Broadway and 8th Street Project – Documentation to be attached to the presentation to City Council
by G. Thorinson

Conclusions of the following Critique of the Proposed Project at Broadway and 8th Street

Photos of Recent builds with Set Backs

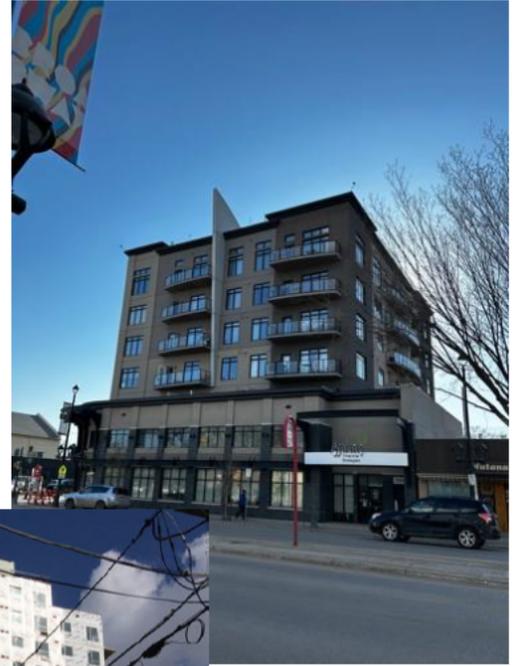
Three recent buildings in the Broadway area can be seen below, keep in mind that these are north of 8th Street and therefore would have higher height allowances, but all have the 2 or 3 stories and then a setback to maintain the Broadway feel and reduce impact on surrounding properties.

- The proposed development is more of a monolithic urban apartment complex not compatible with a Gateway site to the Broadway area and would not be in the spirit or letter of the Corridor Plan guidelines.
- Landscaping is also very minimalistic and numerous large trees have been destroyed instead of moved to the edges to provide shade and separation.
- The rear landscaping primarily consists of a thin strip of some small bushes and reeds at the back. The majority of the flora facing the residential neighbourhood consists of shrub like plants including Turkestan Burning, Borealis Haskap and Snowberry, none of these plants

Angular Plane
Properties that back onto Neighbourhood Areas

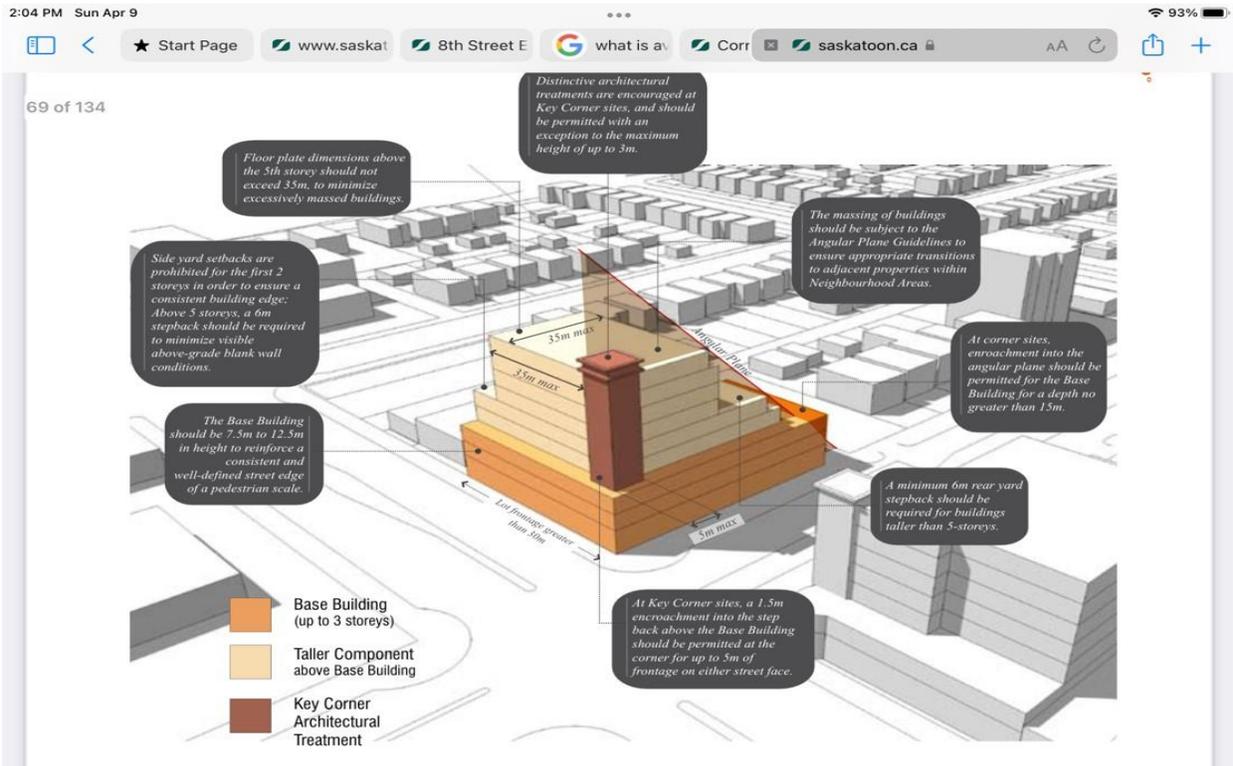
- To avoid encroachment the guidelines suggest a 45 degree angle from the top of the building to the end of the lane behind. Using this formula and the distance proposed – **we get a 2 story building at the northwest corner and a 2 story building at the southwest corner. The proposal is far too large in all aspects but at these critical points there will be far too much shading and also there will be an accident prone turn at both points. As you can see in the photo there is a tight turn at both locations, both of these points will be high risk for automobile accidents with pedestrians, cyclists and passing motor vehicles.**
- Using the 45 degree angle the building is non conforming in over half of the footprint. While a slight deviation might be allowed at a key site like this one, 4 floors over good guidelines would be out of the question.

Angular Plane Guidelines: Note the key architectural treatment request (not present) and tapering that would be required at this site. As can be seen from the developers plans he is making a monolith, creating an unsightly, non conforming building. These guidelines were apparently ignored to maximize the profit for the builder.

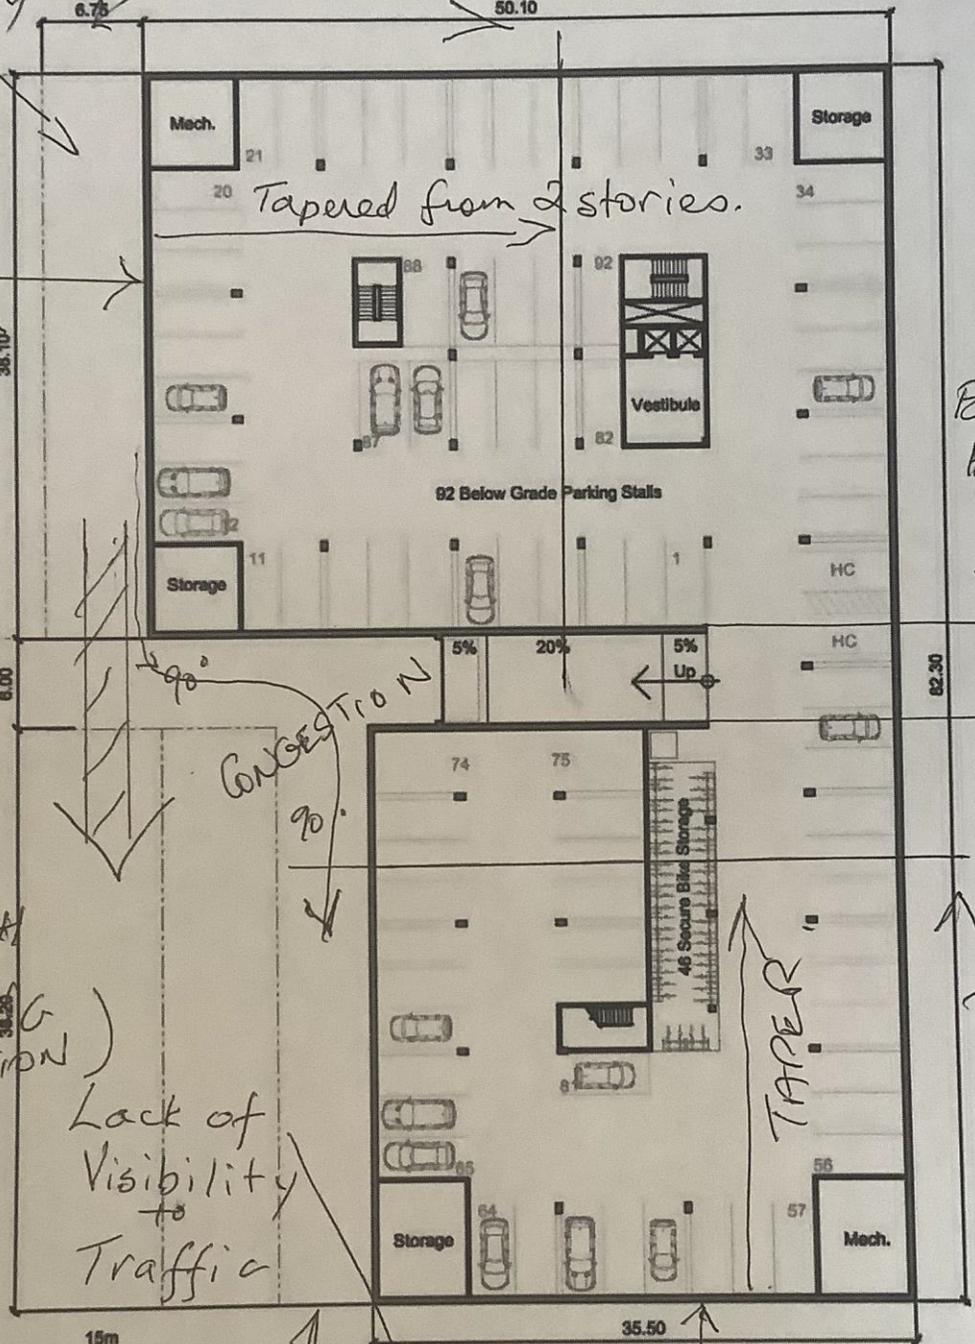
High Accident Zone
Too Close to R2 Property

Lack of Visibility

Neighbouring Property R2 Zoning

2 Stories Maximum

Tapered from 2 stories.

ENTRY/EXIT POINT NEEDED

LANE SHOULD BE STRAIGHT THROUGH (PREVENTING CONGESTION)

CONGESTION

Lack of Visibility to Traffic

Tapered from 2 stories

TAPER

High Accident Zone

2 Stories Maximum

- Lack of a through North South public lane makes the site highly restricted if not impossible for certain vehicles to pass through with ease. **Recommendation – in future revisions the public lane must be just moved so we have a straight through public lane from 7th St. E to 8th St. E. This will avoid congestion and take out the 90 degree angles that are currently there. Traffic congestion and accidents are guaranteed if we leave the back design as shown.**
